Meadowbank Education Precinct Schools Project Modification 2

State Significant Development Modification Assessment
(SSD 9343 MOD 2)

December 2020

Figure 8: Canopy roof as originally approved (Source: Department's original Assessment Report 2020)

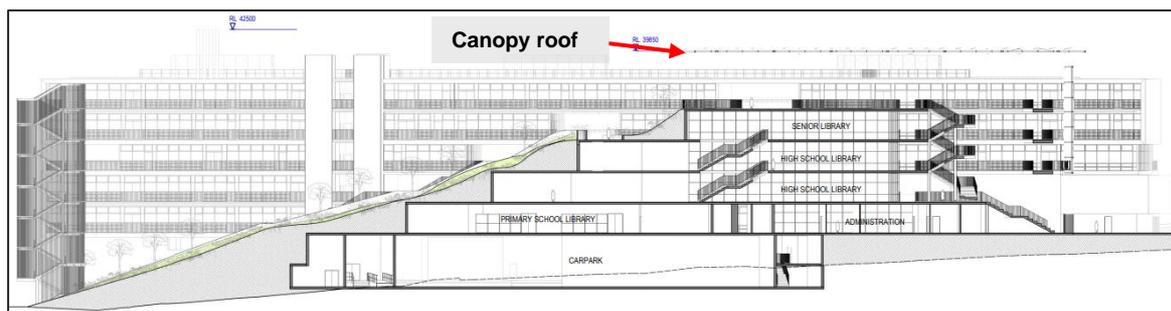
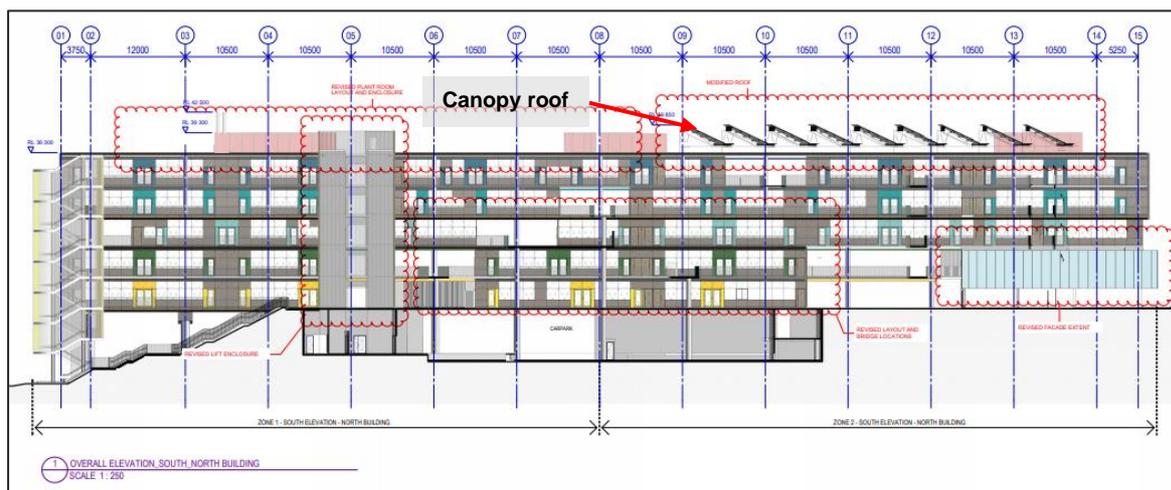
The Department identifies that the biggest deviation from the original approval is the design of the canopy roof. The originally approved canopy roof design (**Figure 8**) was characterised by a large flat roof form. The proposed modified canopy roof (**Figure 9**) is characterised by nine free standing skillion roofs, arranged in a row, covering the same extent as the original design.

The Department considers that this revision to the canopy roof design is acceptable as the height, bulk and scale of the building does not increase, amenity is still being provided to roof top users, the changes would not be easily perceivable at street level and that the overall design characteristics of the originally approved development are not detrimentally impacted upon.
